DEVELOPMENT APPLICATION ASSESSMENT REPORT

DA2022/1452

Responsible Officer:	Phil Lane	
Land to be developed (Address):	Lot 421 DP 1004511, 32 A Nareen Parade NORTH NARRABEEN NSW 2101	
Proposed Development:	Alterations and additions to a dwelling house	
Zoning:	C4 Environmental Living	
Development Permissible:	Yes	
Existing Use Rights:	No

Figure 2 - Western elevation building envelope breach (indicated in red)

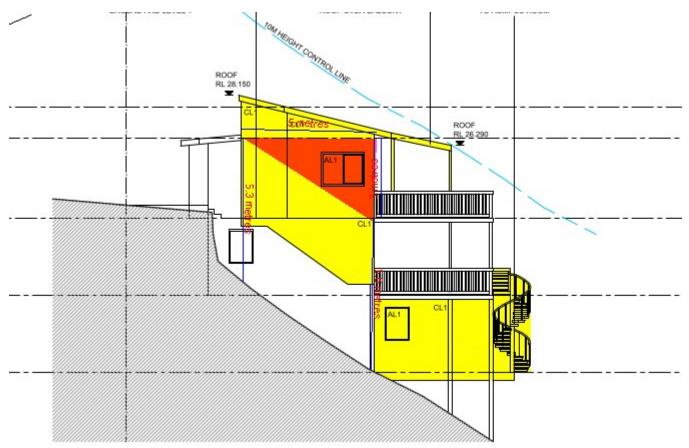
Under Clause D11.9 of the DCP, buildings are required to be sited within the building envelope which is measured from a height of 3.5m above ground level and projected 45 degrees at the side boundaries.

The proposal presents a building envelope encroachment on the west elevation of maximum of 3m for a horizontal length of 5m (see Figure 2 below). Notably, the existing dwelling house is numerically non-compliant with the building envelope control along both side elevation and the site has significant fall of 20m from the top to the bottom (slope of 39%).

With regard to the request for a variation, the development is considered against the underlying outcomes of the control as follows:

existing dwelling house presents building envelope encroachments along both side elevations. In this regard, the proposal is considered to respond to, reinforce, and sensitively relate to the existing spatial characteristics of the built and natural environment.

The proposed development is compliant with the development standard for building height prescribed by the PLEP 2014. Moreover, given the existing numerically non-compliant building envelope encroachment, the proposal is not anticipated to result in any additional unreasonable height, bulk or scale.

The building envelope non-compliance are not anticipated to result in any adverse impacts to privacy, overshadowing or loss of amenity to adjoining and surrounding residential properties. The existing levels of amenity enjoyed by neighbouring properties will be preserved given the resultant dwelling house will be of a similar size and scale to the existing dwelling.

Having regard to the above assessment, it is concluded that the proposed development is consistent with the relevant outcomes of the P 21 DCP 2014 and the objectives specified in s1.3 of the Environmental Planning and Assessment Act 1979. Accordingly, this assessment finds that the proposal is supported, in this particular circumstance.
